# ***Next Generation Nuclear Plant***

## ***Risk-Informed Performance-Based Licensing Approach***

### ***Responses to LBE Actions***

July 10, 2012

# Comparison of NGNP TLRC with NUREG-1860

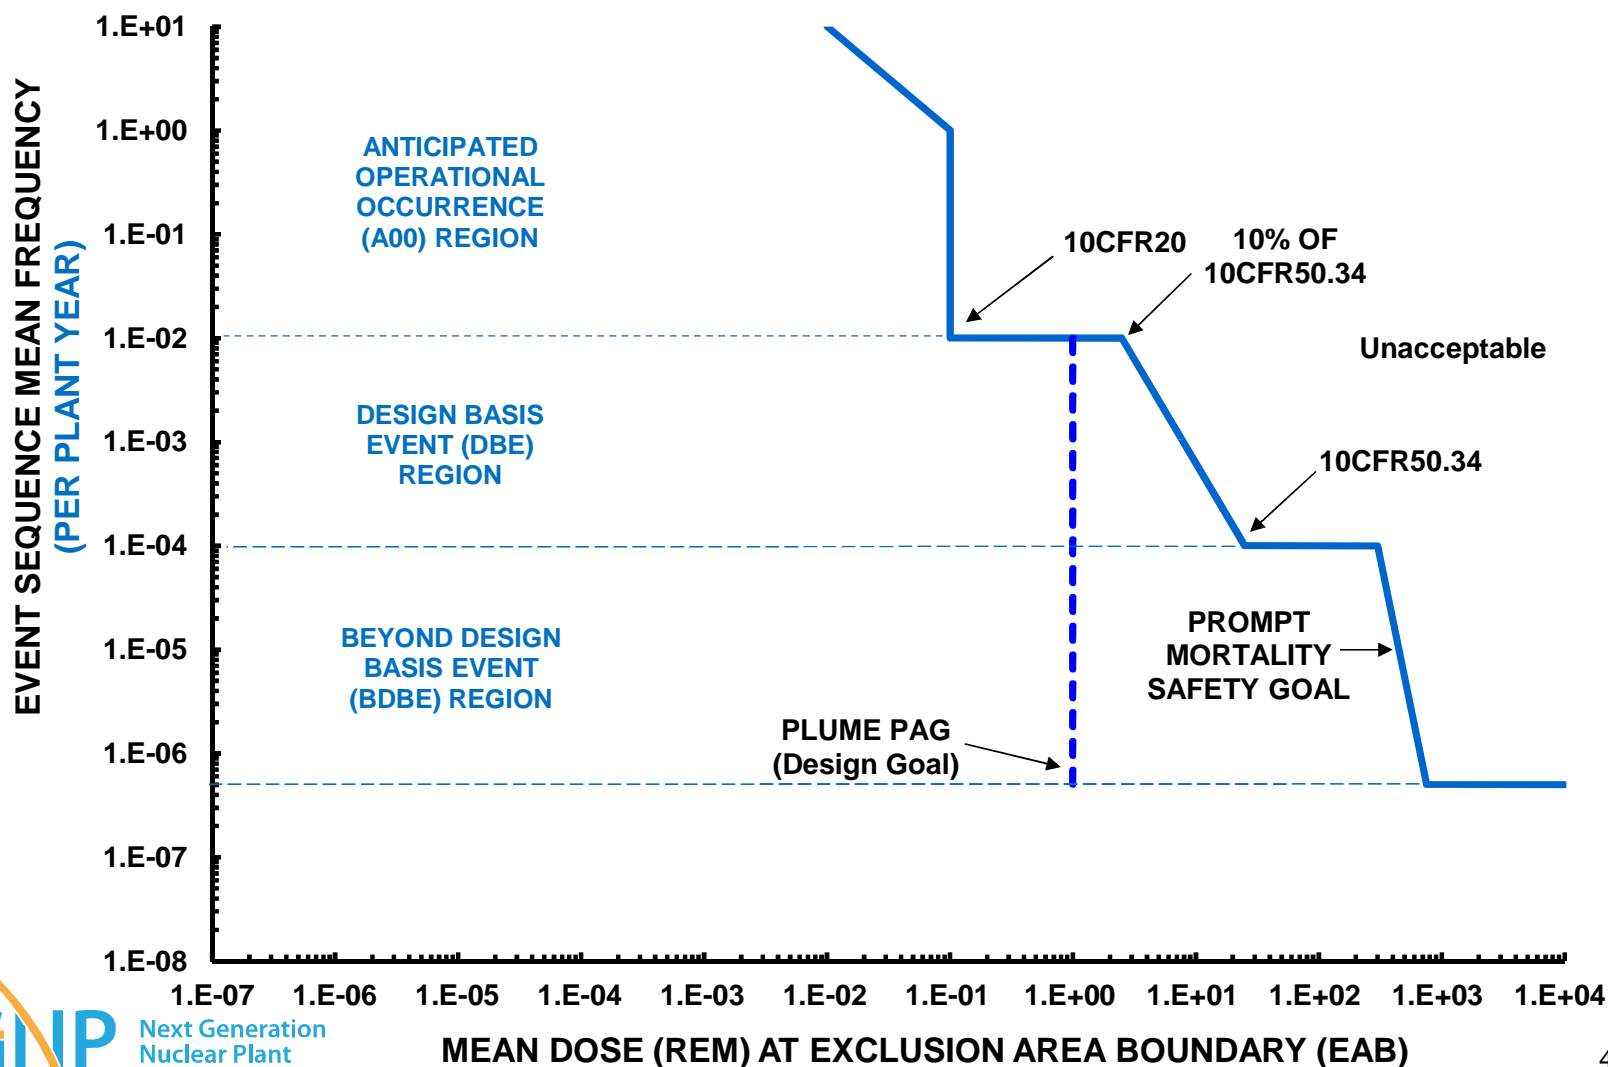
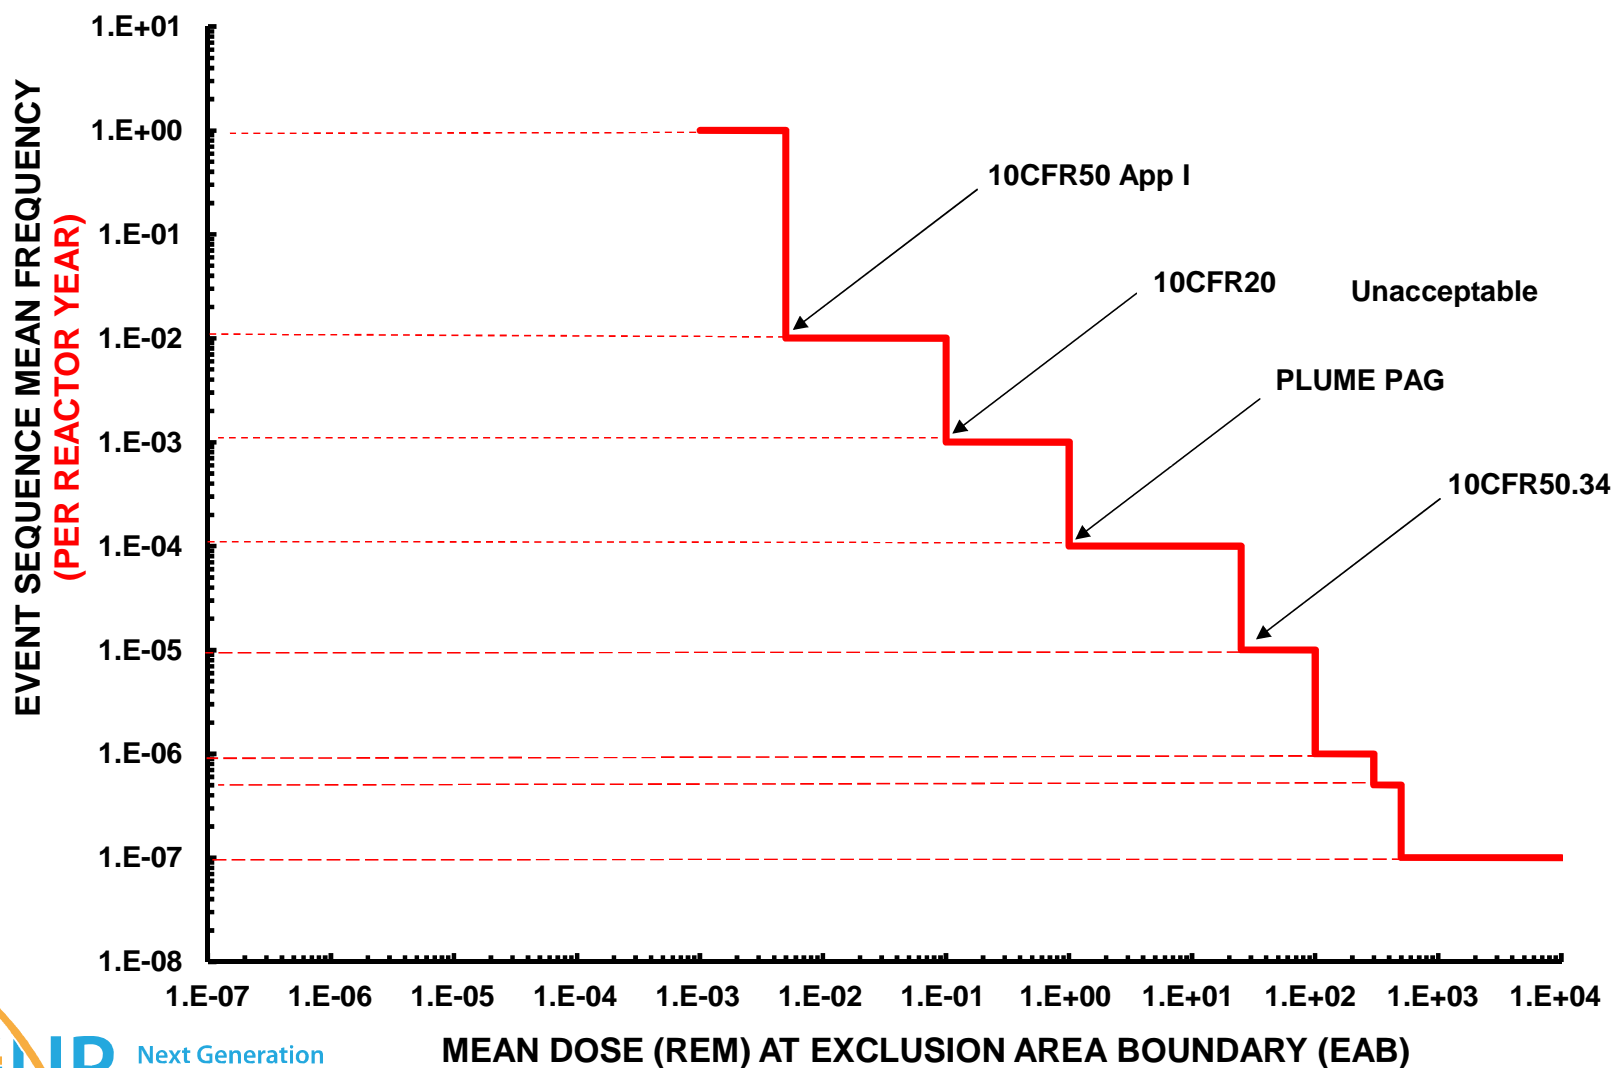
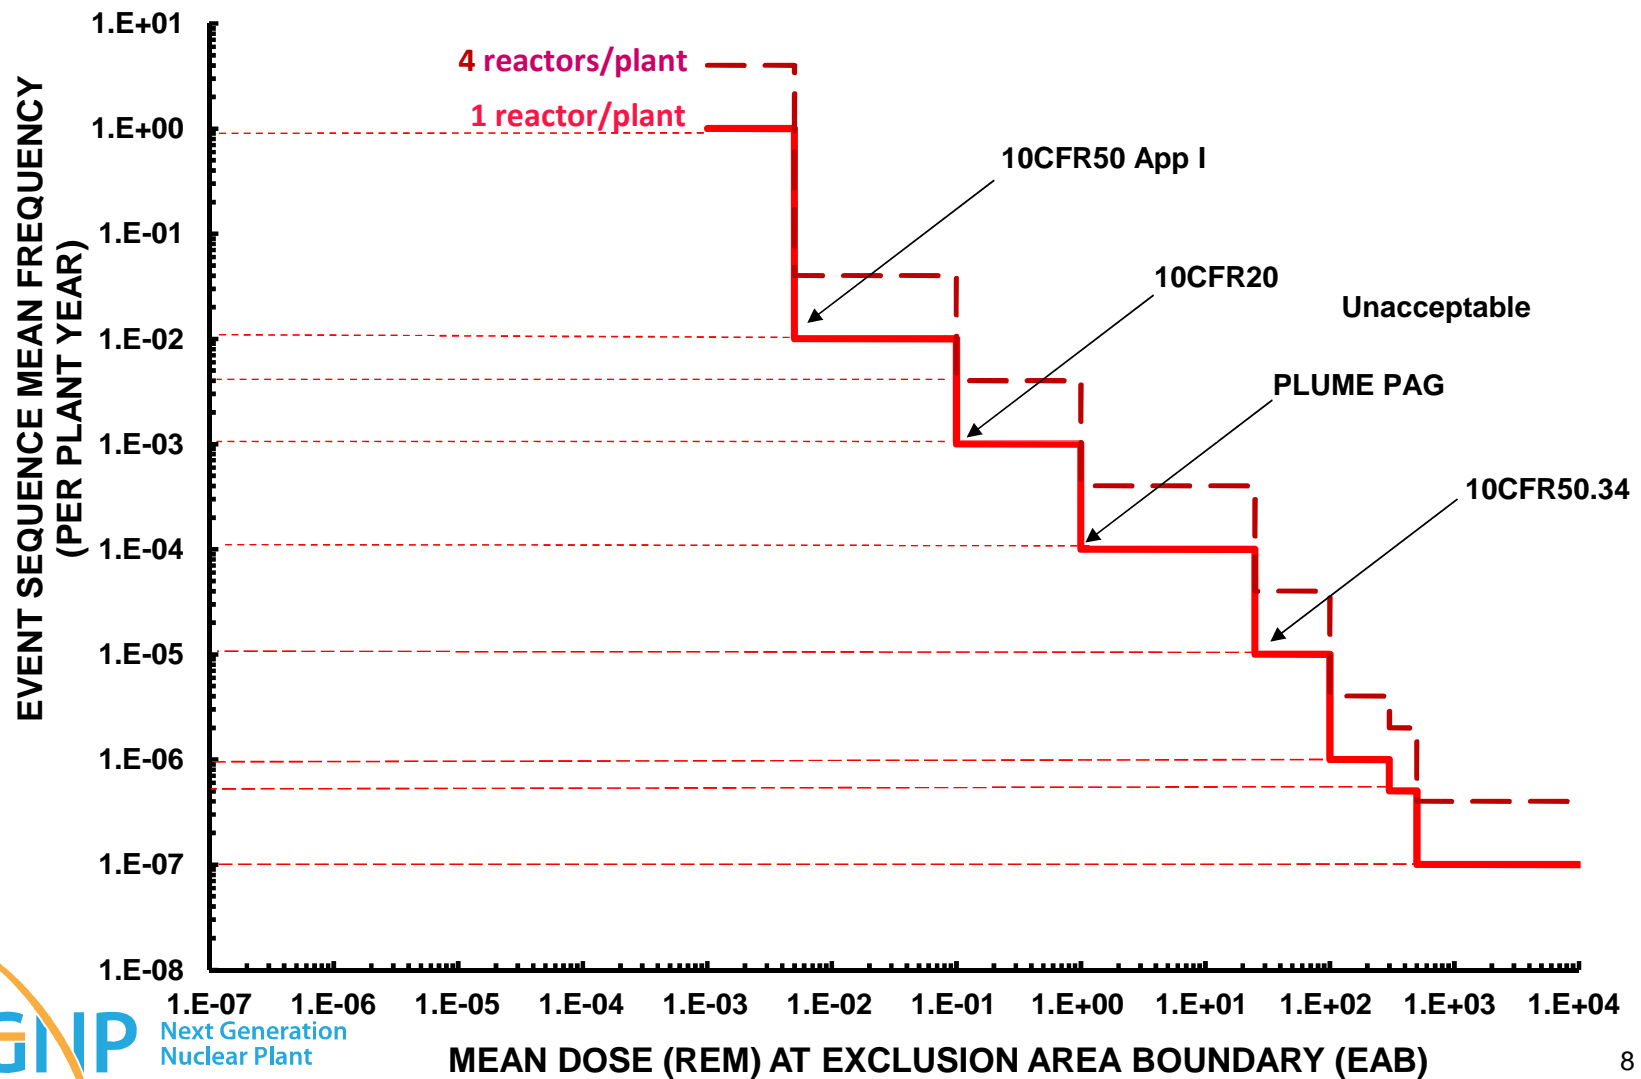
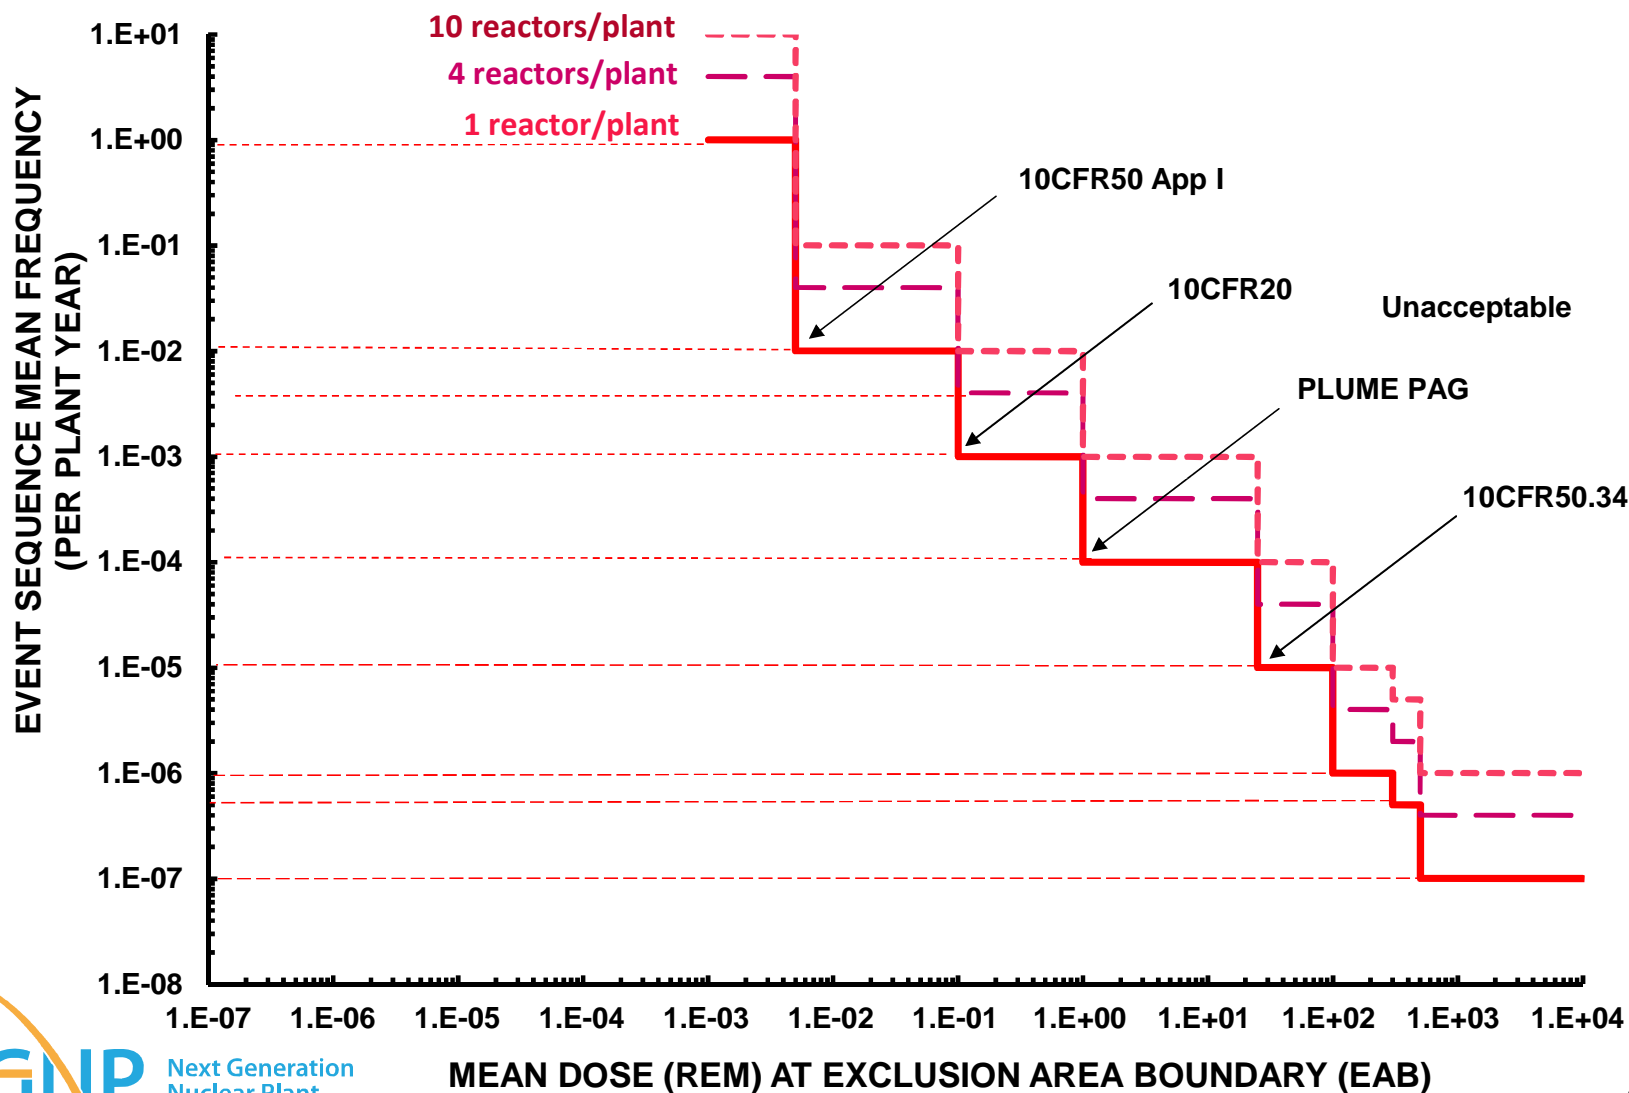
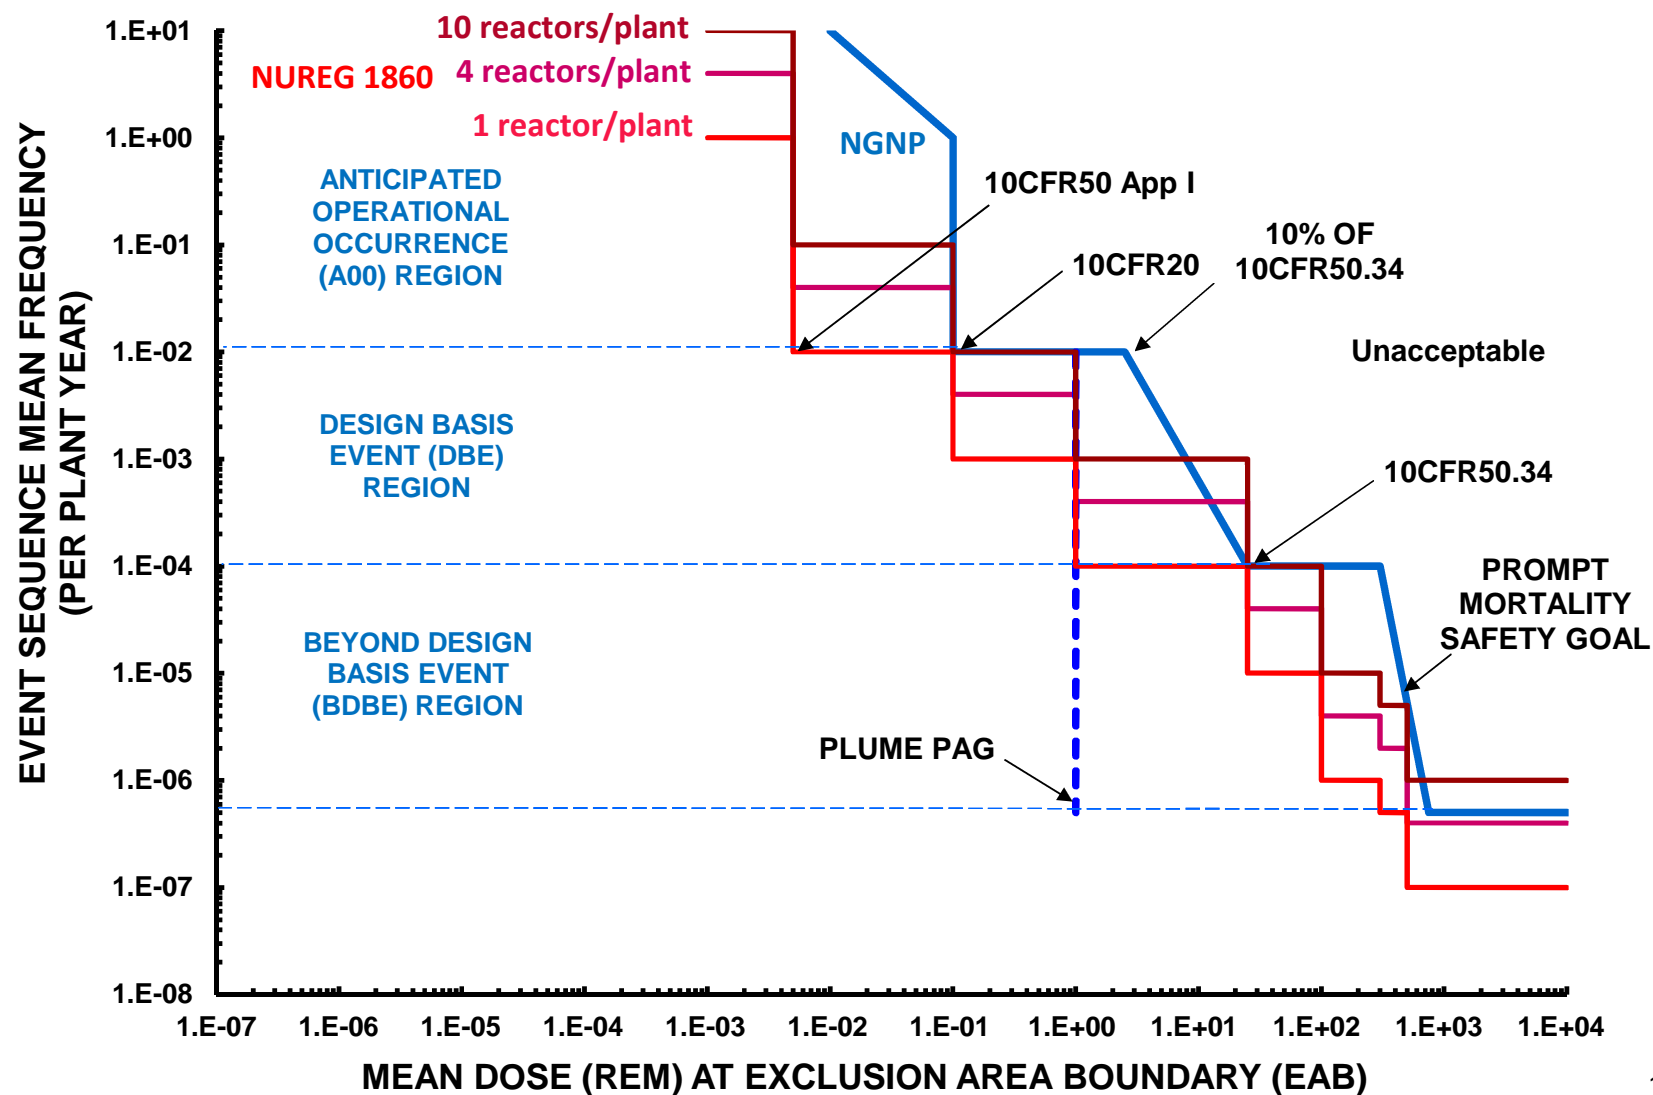
- **Action** - NGNP should compare at a future meeting its F-C curve to that of NUREG-1860 by adding another ordinate for reactor-year frequency and overlaying the two curves. A discussion should be provided on whether or not the NGNP curve's anchor points correspond to those on the NUREG-1860 curve. NGNP should discuss what the differences mean and what the NGNP curve captures differently from that depicted in NUREG-1860.
- **Response** – Next slides

## ***NUREG-1860 F-C Curve Has More Anchor Points and Regions Than NGNP***

<b>Anchor Point</b>	<b>NGNP TLRC</b>	<b>NUREG 1860</b>	<b>Notes</b>
10CFR50 App I (5 mrem)		Yes	ALARA goal
<b>10CFR20 (100 mrem)</b>	Yes	Yes	<b>Agree on need for dose on F-C curve</b>
EPA PAG (1 rem)	Yes*	Yes	Applies to all DBEs and BDBEs *Design goal at EAB for NGNP
<b>10CFR50.34 (25 rem)</b>	Yes	Yes	<b>Agree on need for dose on F-C curve</b>
100 rem		Yes	Regulatory basis unclear
<b>Prompt QHO (300 rem)</b>	Yes	Yes	<b>Agree on need for dose on F-C curve</b>
500 rem		Yes	Regulatory basis unclear
<b>Prompt QHO (750 rem)</b>	Yes		<b>Needs to be on F-C curve</b>

## ***NGNP and NUREG-1860 F-C Curve Frequencies Not in Same “Units”***

<b>Anchor Point</b>	<b>NGNP TLRC</b>	<b>NUREG 1860</b>	<b>Notes</b>
10CFR50 App I (5 mrem)	-	$10^{-2}/\text{r-yr}$	ALARA goal
10CFR20 (100 mrem)	$10^{-2}/\text{pl-yr}$	$10^{-3}/\text{r-yr}$	Agree on need for dose on F-C curve
EPA PAG (1 rem)	$10^{-2}/\text{pl-yr}$ to $5 \times 10^{-7}/\text{pl-yr}^*$	$10^{-4}/\text{r-yr}$	Applies to all DBEs and BDBEs *Design goal at EAB for NGNP
10CFR50.34 (25 rem)	$10^{-4}/\text{pl-yr}$	$10^{-5}/\text{r-yr}$	Agree on need for dose on F-C curve
<b>100 rem</b>	-	$10^{-6}/\text{r-yr}$	<b>100 rem at NUREG-1860 frequency Is more restrictive than QHO risk</b>
<b>Prompt QHO (300 rem)</b>	$10^{-4}/\text{pl-yr}$	$5 \times 10^{-7}/\text{r-yr}$	Agree on need for dose on F-C curve <b>300 rem at NUREG-1860 frequency Is more restrictive than QHO risk</b>
<b>500 rem</b>	-	$10^{-7}/\text{r-yr}$	<b>500 rem at NUREG-1860 frequency Is more restrictive than QHO risk</b>
Prompt QHO (750 rem)	$5 \times 10^{-7}/\text{pl-yr}$	-	Needs to be on F-C curve

## Comparison of 4-Reactor F-C Anchor Point Frequencies

Anchor Point	NGNP TLRC	NUREG 1860 (4 reactors)	Notes
10CFR50 App I (5 mrem)	-	$4 \times 10^{-2}/\text{pl-yr}$	ALARA goal
10CFR20 (100 mrem)	$10^{-2}/\text{pl-yr}$	$4 \times 10^{-3}/\text{pl-yr}$	Agree on need for dose on F-C curve
EPA PAG (1 rem)	$10^{-2}/\text{pl-yr}$ to $5 \times 10^{-7}/\text{pl-yr}^*$	$4 \times 10^{-4}/\text{pl-yr}$	Applies to all DBEs and BDBEs *Design goal at EAB for NNGP
10CFR50.34 (25 rem)	$10^{-4}/\text{pl-yr}$	$4 \times 10^{-5}/\text{pl-yr}$	Agree on need for dose on F-C curve
<b>100 rem</b>	-	$4 \times 10^{-6}/\text{pl-yr}$	<b>100 rem at that frequency Is more restrictive than QHO risk</b>
<b>QHO (300 rem)</b>	$10^{-4}/\text{pl-yr}$	$2 \times 10^{-6}/\text{pl-yr}$	Needs to be on F-C curve <b>300 rem at that frequency Is more restrictive than QHO risk</b>
<b>500 rem</b>	-	$4 \times 10^{-7}/\text{pl-yr}$	<b>500 rem at that frequency Is more restrictive than QHO risk</b>

## ***Observations from Comparison of NUREG-1860 Anchor Points and FC Curve with NGNP***

- Major difference is frequency metric on a per reactor year vs. per plant year basis
- 10CFR20 is the higher plant level requirement at the EAB rather than 10CFR50 Appendix I
- Three regions have precedent in current practice (e.g., SAR Chapters 11, 15 and 19)
- NUREG-1860 BDBE F-C steps do not correspond to QHO
- NUREG-1860 is more restrictive than the NGNP curve; but becomes less restrictive as more modules are included in the plant design
